Wisconsin Department of Transportation

Proposal #21: 1000-28-28
NW Region, Tree Clearing 2025
Northwest Region Wide
Non Hwy
NW Region Various Counties

This is Addendum No. 01, which provides for the following:

ADDENDUM NO. 01

Addendum No. 01
ID 1000-28-28
Revised Sheet 1
August 29, 2024

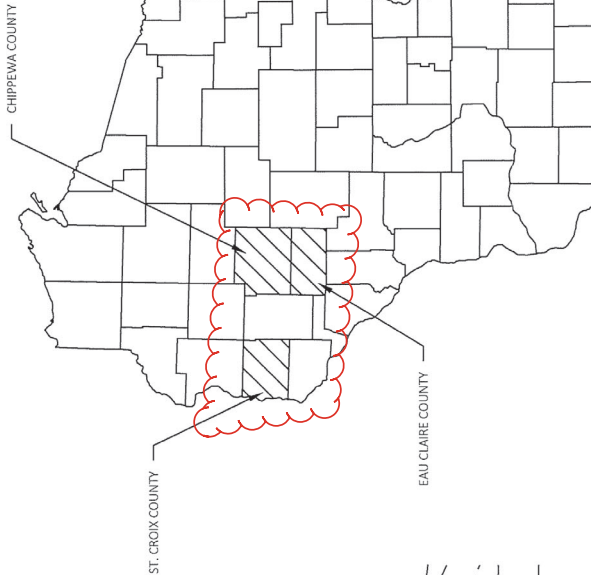
Revised Plan Sheets	
Plan Sheet	Plan Sheet Title (brief description of changes to sheet)
1	Remove shaded counties that are not included
3	Update contacts to only include site 1, 7 and 12
9	Update table
10	Update site
11	Update site
12	Update site and add note 'future work order sites, for information only'
13	Update site and add note 'future work order sites, for information only'
14	Update site and add note 'future work order sites, for information only'
15	Update site and add note 'future work order sites, for information only'
23	Update msq
24	Update msq
25-32	Add note 'For Information Only'
45-53	Add note 'For Information Only'
